Mobile Intel® Celeron® Processor on .13 Micron Process in Micro- FCPGA Package

Specification Update

Document Number: 251309-022

Figure 12. System Bus Reset and Configuration Timings

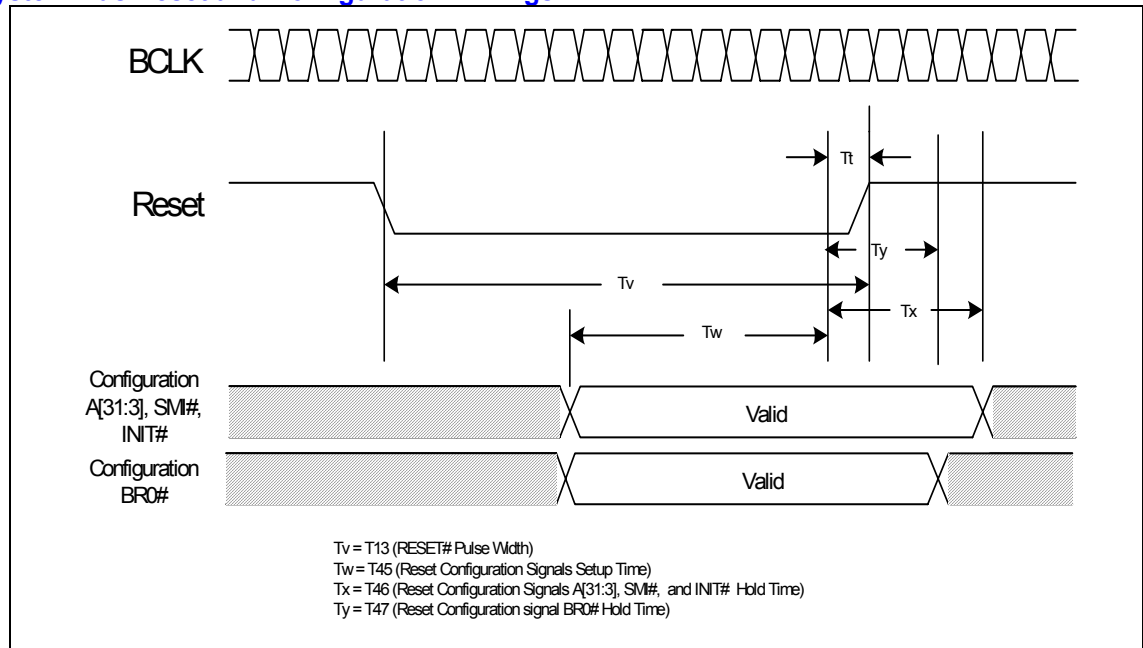
2. BR0# Maximum Hold Time Specification Change

The BR0# maximum hold time has changed to 2 BCLKs. This change will be shown in the “System Bus AC Specifications (Reset Conditions)” table and “System Bus Reset and Configuration Timings” figure of the *Mobile Intel® Celeron® Processor on .13 Micron Process in Micro-FCPGA Package Datasheet*. This change will be incorporated in the next revision of the datasheet.

The following figure is modified to reflect this change:

T# Parameter	Min	Max	Unit	Figure	Notes
T45: Reset Configuration Signals (A[31:3]#, BR0# INIT#, SMI#) Setup Time	4		BCLKs	13	1
T46: Reset Configuration Signals (A[31:3]#, INIT#, SMI#) Hold Time	2	20	BCLKs	13	2
T47: Reset Configuration Signal BR0# Hold Time	2	2	BCLKs	13	2
